## **REACTOR CORE THERMAL-HYDRAULIC ANALYSIS USING THE COBRA IIIC/MIT COMPUTER CODE**

Subject: Acceptance for Referencing of Licensing Topical Report  
VEP-FRD-33, "VEPCO Reactor Core Thermal-Hydraulic Analysis  
Using the COBRA-IIIC/MIT Computer Code"

## TOPICAL REPORT EVALUATION

Report Title: Virginia Electric & Power Company Reactor Core Thermal-Hydraulic Analysis Using the COBRA IIIC/MIT Computer Code  
Report Number: VEP-FRD-33  
Report Date: August 1979  
Responsible Branch: Standardization and Special Projects  
DSI Branch Involved: Core Performance Branch

COMPARISON OF DNB DATA WITH COBRA PREDICTIONS

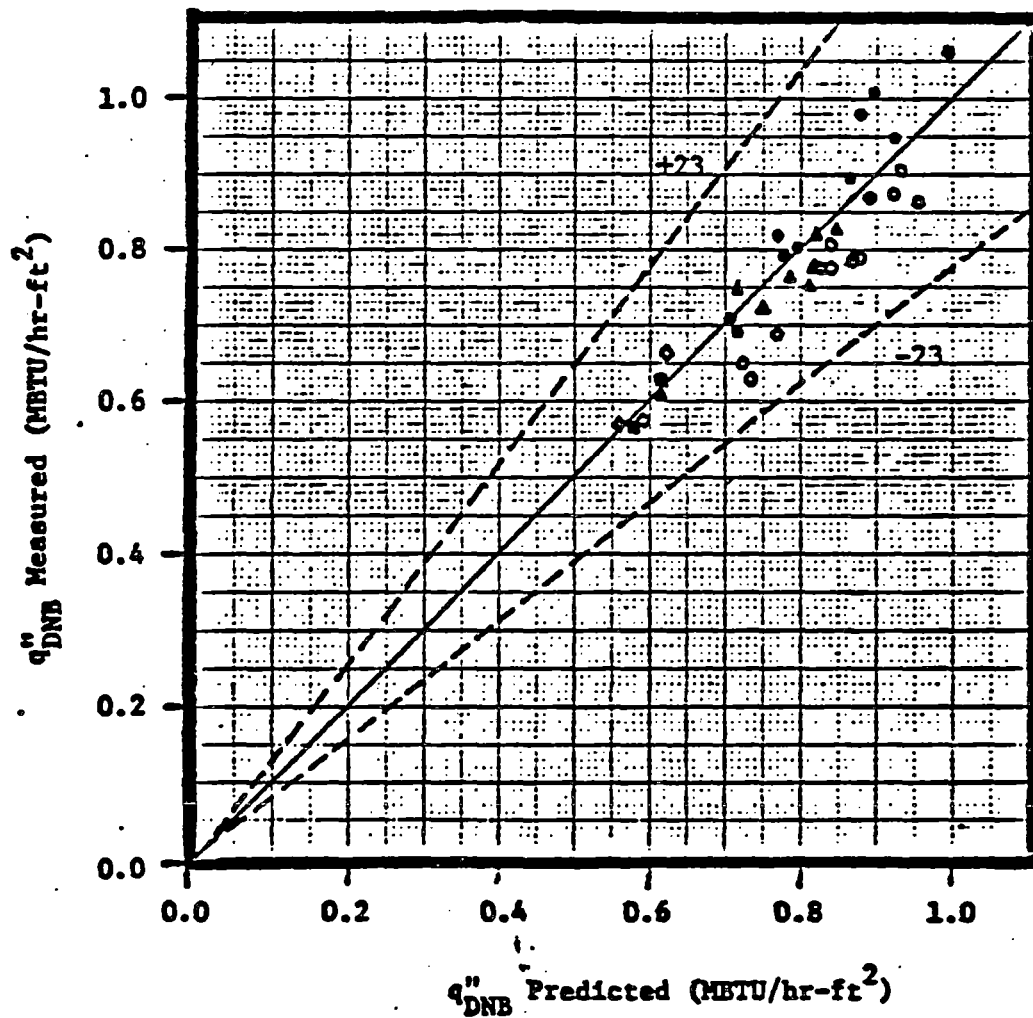
As part of our review, the staff chose Cases 1 and 7 to perform audit calculations of VEPCO methodology using COBRA-IV. Our analyses were performed in two steps. First, an eighth core symmetric core-wide calculation was performed to determine the flow to the hot assembly. This crossflow was stored on tape and used as a boundary condition in the subchannel calculations. For the subchannel case, an octant of the limiting assembly was modeled on a rod-by-rod basis. The cases selected were those that had the greatest deviation between COBRA-IIIC/MIT and THINC-I. Table 7 contains the operating conditions for the cases analyzed while Table 8 presents a comparison of the results.

From Table 8, it can be seen that there is good agreement between the staff's detailed audit calculations and VEPCO's COBRA-IIIC/MIT results. In both cases, VEPCO is conservative when compared to our results.
